ALLIANCE CONSULTING ENGINEERS, INC.

To: All Bidders and Plan Holders Project No. 13176-0032
Re: Addendum No. 3 Provided: E-Mail
Project: Phase II Infrastructure Improvements at the Chapin Business and
Technology Park in Lexington County, South Carolina
Date: Wednesday, January 7, 2015
Bid Date: Monday, January 12, 2015 at 2:00 P.M.
Bid No.: B15029-01/12/15S Page 1 of 64

A. Clarifications to Contract Documents and Specifications:

FILE NAME:	C44.DWG	SHEET
REFERENCE FILE:	SURVEY.DWG	OF
PROJECT NO.:	13176-0032	73
DWG NO.:	01.782-D14

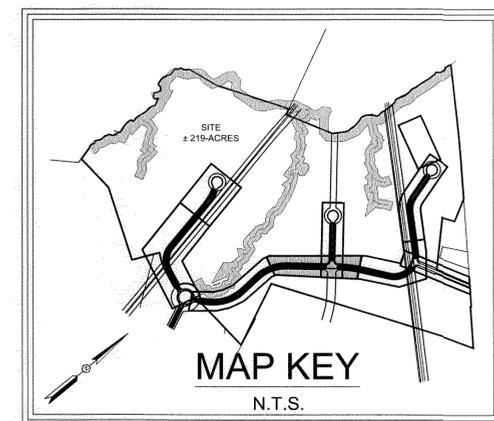
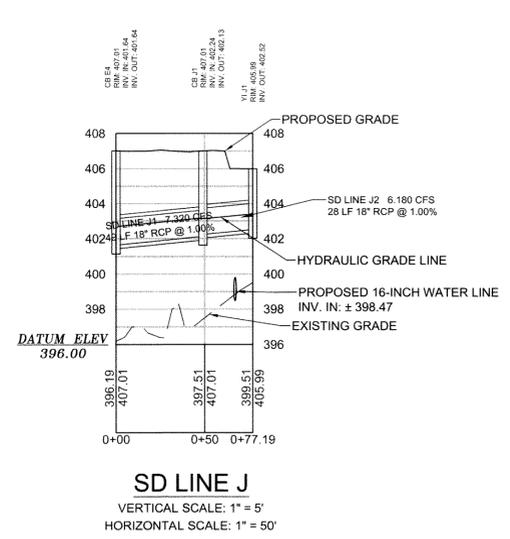
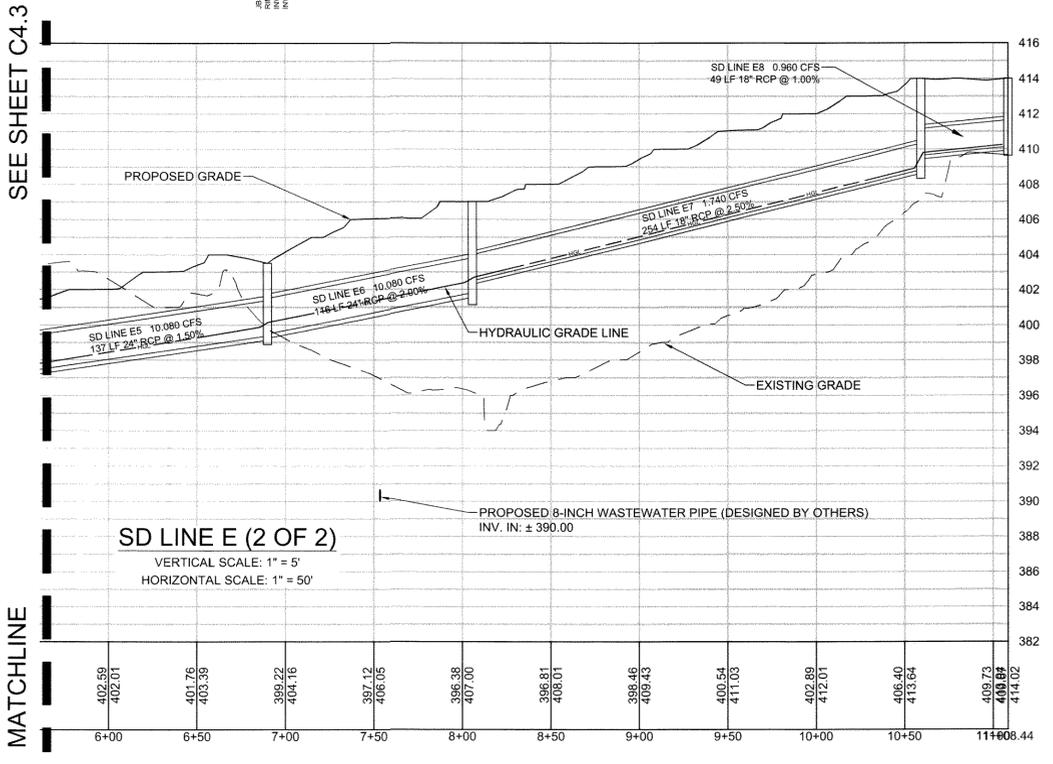
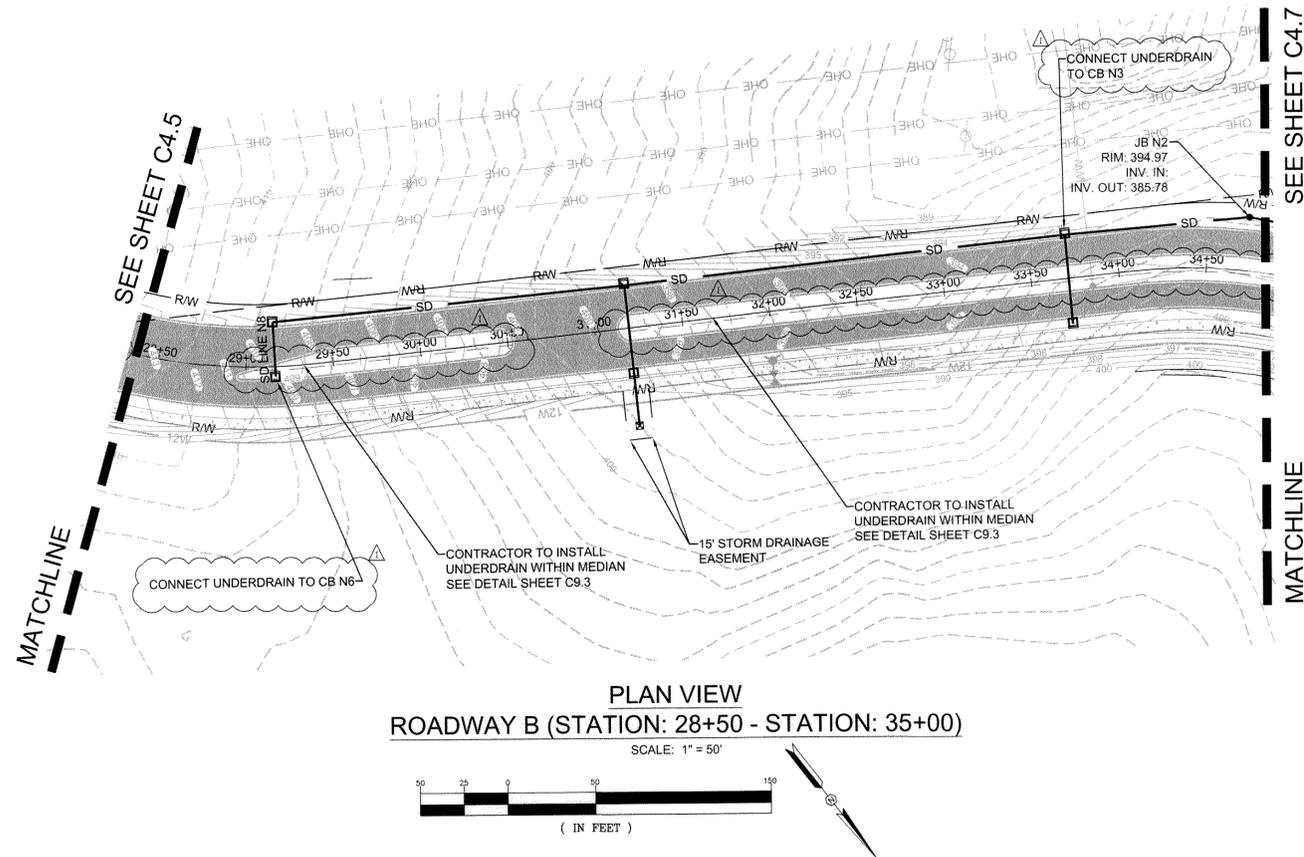
27. *Please provide connection locations for 10” median drain on storm drainage plans.*
- a. **Refer to Alliance Consulting Engineers, Inc. drawings (Dwg. No. 01,782-D14, dated September 2013) Sheets C4.1 through C4.8 revised January 6, 2015 for underdrain information. Sheets C4.1 through C4.8 have been enclosed.**

- a. Lights are required to be centered. Alliance Consulting Engineers, Inc. drawings (Dwg. No. 01,782-D14, dated September 2013) Sheets C4.1 through C4.8 revised January 6, 2015 indicate the location of the median under drain, which is offset from the center of the median to avoid a conflict with lighting. Sheets C4.1 through C4.8 have been enclosed.**

A
LS-1
ENTRANCE SIGN LAYOUT PLAN
SCALE 20"=1'

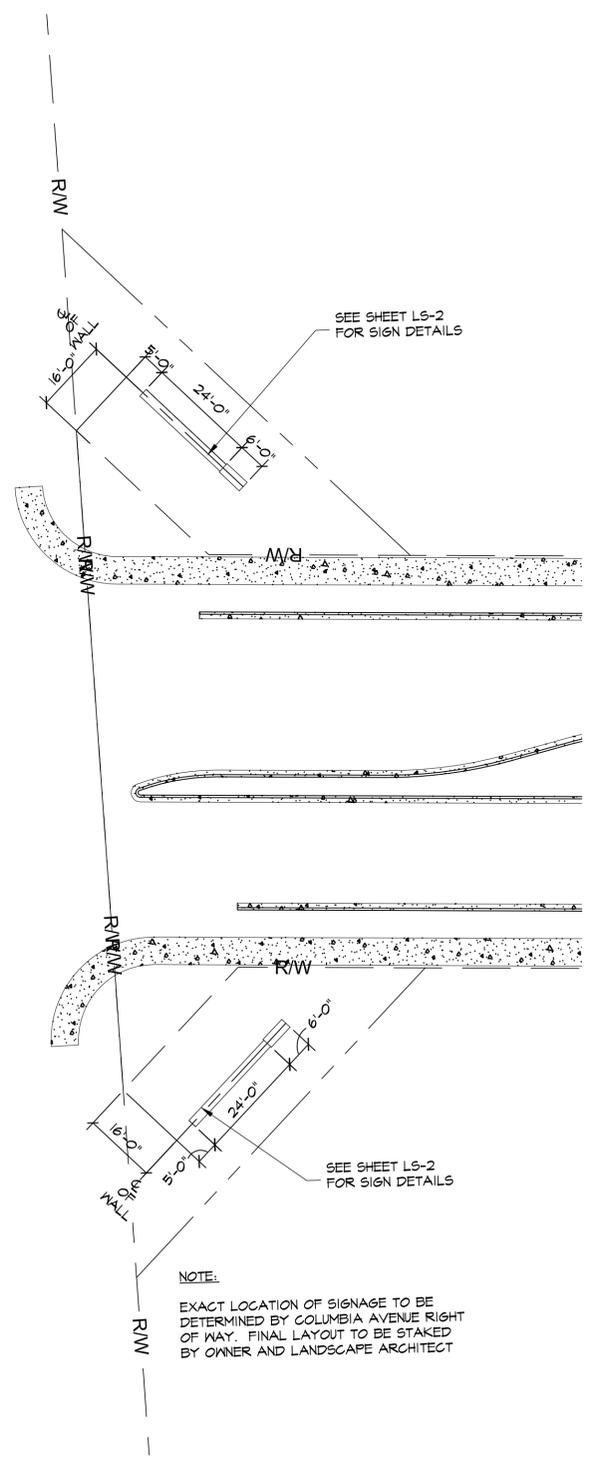
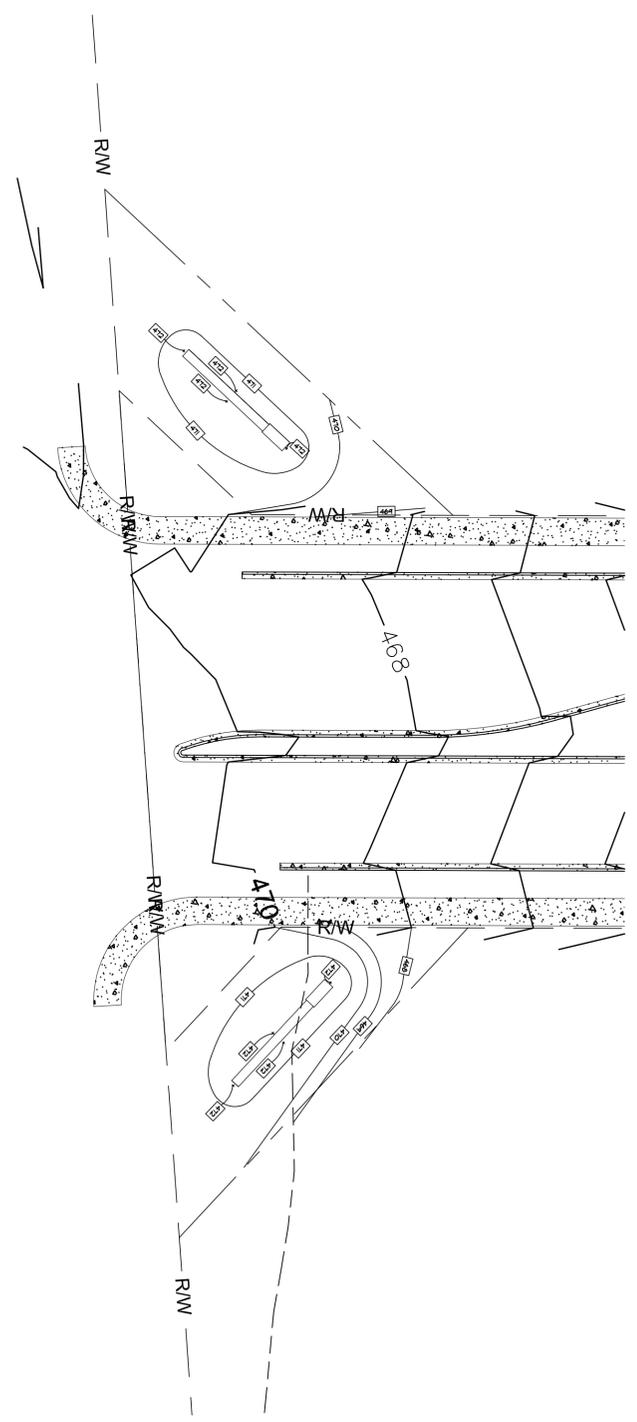
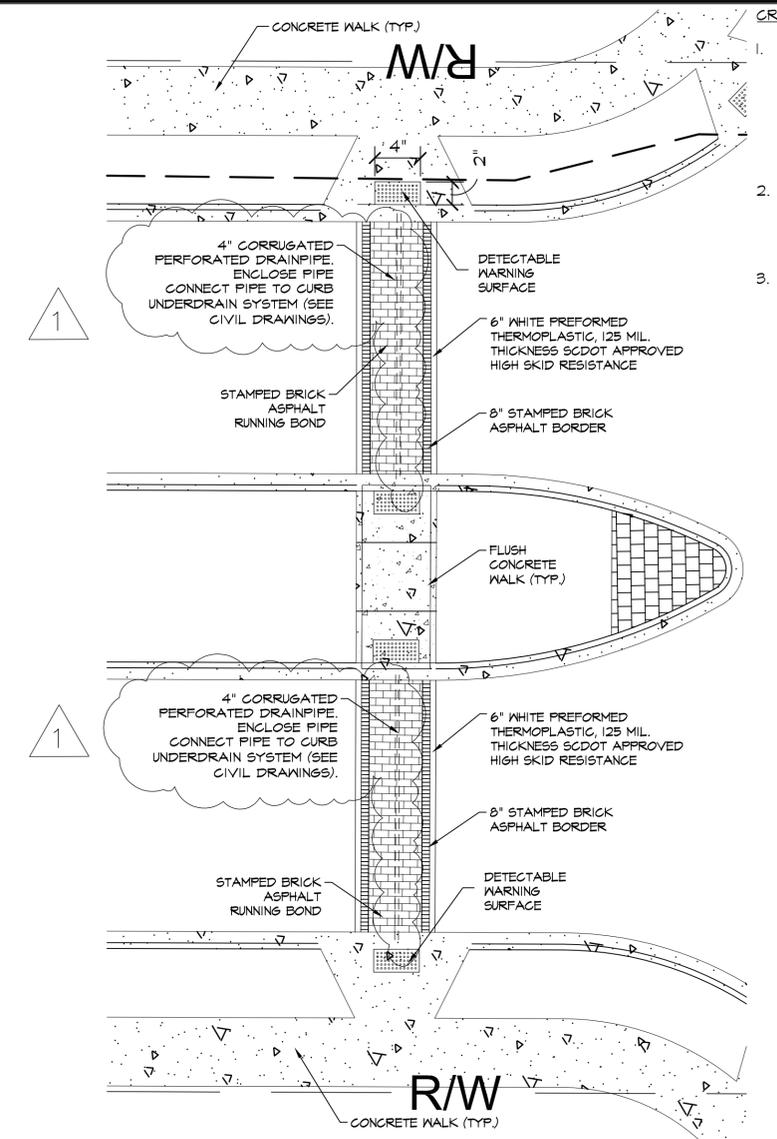
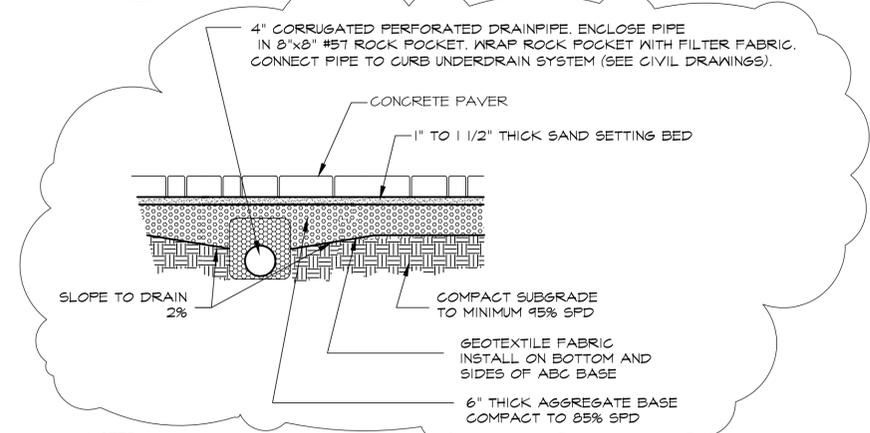
17. *Alliance Consulting Engineers, Inc. Dwg. No. 01,782-D14, dated September 2013, Sheet LS-1 Detail D. Please show location of 4" Perforated Drain Pipe on plan view.*

19. *On Bid Form please clarify Phase II Landscape Items 2, 3, and 4 as they relate to Detail C on sheet LS-1 Drawing of Alliance Consulting Engineers, Inc. Dwg. No. 01,782-D14, dated September 2013 . Is Line Item No. 2 for the 8-inch Stamped Brick Border? Is Line Item No. 3 for the 6-inch white Preformed Thermoplastic and is Line Item No. 4 for the Stamped Brick Asphalt?*

- a. **Alliance Consulting Engineers, Inc. Dwg. No. 01,782-D14, dated March 2014 revised January 7, 2015, Sheet LS-1 has been revised to show location of 210 LF 4-inch Perforated Drain Pipe on plan view. In addition the Bid Form (Section 00410) has been revised to reflect 210 LF of 4-inch Perforated Drain Pipe as Bid Item No. 55 under Phase II Landscape Improvements (Drawing No. 07,782-D14, dated September 2013). Sheet LS-1 and Bid Form have been revised and enclosed.**

REVISION DATE	
revise detail, show in plan 1.7.15	
APPROVALS	DESIGNER WRW
CHECKED BY KVC/JWF	DATE:
ALLIANCE CONSULTING ENGINEERS	
GRIMBALL & ASSOCIATES COTTERILL LANDSCAPE ARCHITECTS & LAND PLANNERS 600 BELTLINE BOULEVARD COLUMBIA, SC 29205 (803)728-9235	
PROJECT phase II roadway improvements for THE CHAPIN business AND technology park FOR LEXINGTON COUNTY	DATE: MARCH 2014 SCALE:
FILE NAME: ENTRANCE PLANS AND DETAILS	SHEET LS-1
REFERENCE FILE: BASE.DWG	OF
PROJECT NO. 13176-0032	DWG NO. 01,782-014
